SUBJECT: Savannah River Site's Responses to the Regulatory Comments on the Effectiveness Monitoring Report for the Monitored Natural Attenuation (MNA) at the Chemicals, Metals, and Pesticides (CMP) Pits Operable Unit (OU) (U) March 2018 through March 2019 (SRNS-RP-2019-00274, Revision 0, June 2019) SEMS Number: 24

SRS Responses to SCDHEC Comments on the Effectiveness Monitoring Report for the Monitored Natural Attenuation (MNA) at the Chemicals, Metals, and Pesticides (CMP) Pits Operable Unit (U) March 2018 through March 2019

SRNS-RP-2019-00274; Rev.0, Dated June 2019

SRS Responses to USEPA Comments on the Effectiveness Monitoring Report for the Monitored Natural Attenuation (MNA) at the Chemicals, Metals, and Pesticides (CMP) Pits Operable Unit (U) March 2018 through March 2019

Figure of Independent Pen Branch Sampling Area and Summary of 2018 Results for VC

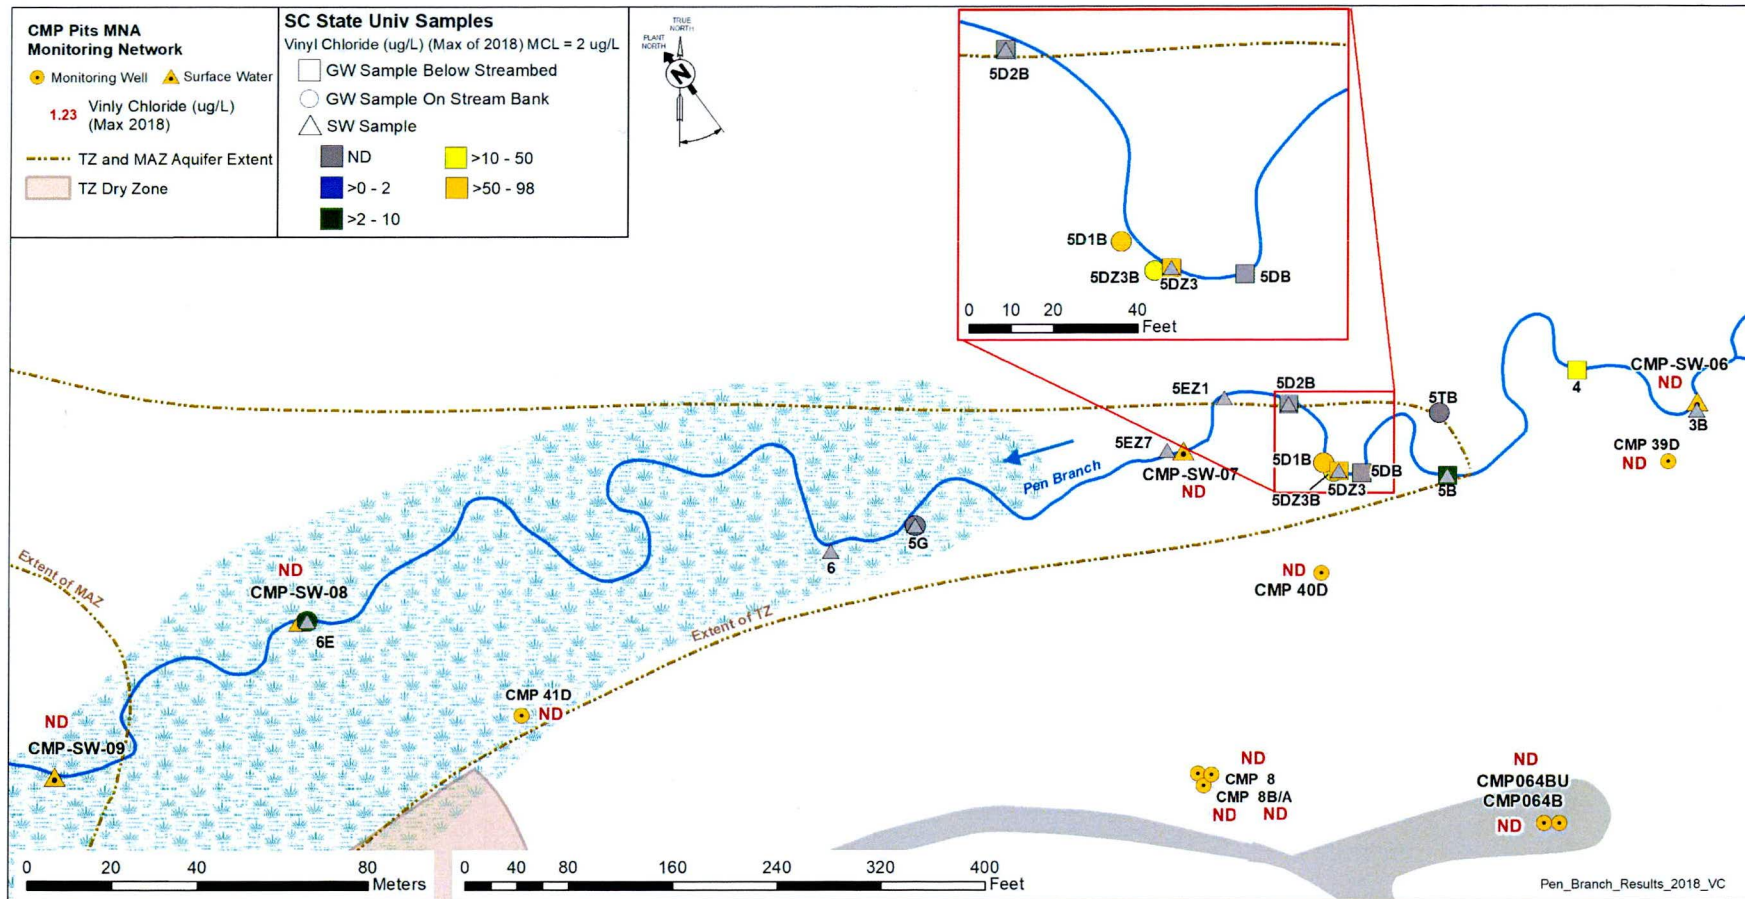
1. Section 2.2.4, Additional Data from Independent Analysis, pages 21 and 22, and Figures 32 and 33. The last sentence of page 21, which discusses c-1,2-DCE surface water sampling results, refers to Figure 32 which shows PCE results. Also, the first sentence of page 22 mentions VC surface water results and references Figure 33, which shows c-1,2-DCE results. There is no figure provided that shows VC surface water results. Please correct.

Response: Agree/Clarification

The c-1,2-DCE map should have been provided as Figure 32 and a VC map should have been supplied in Figure 33. Errors will attempt to be avoided in future reports.

A map of 2018 results of VC is provided on the next page. SCSU VC data can also be seen in Table 6 and Table 7. No changes to the 2019 EMR are proposed.
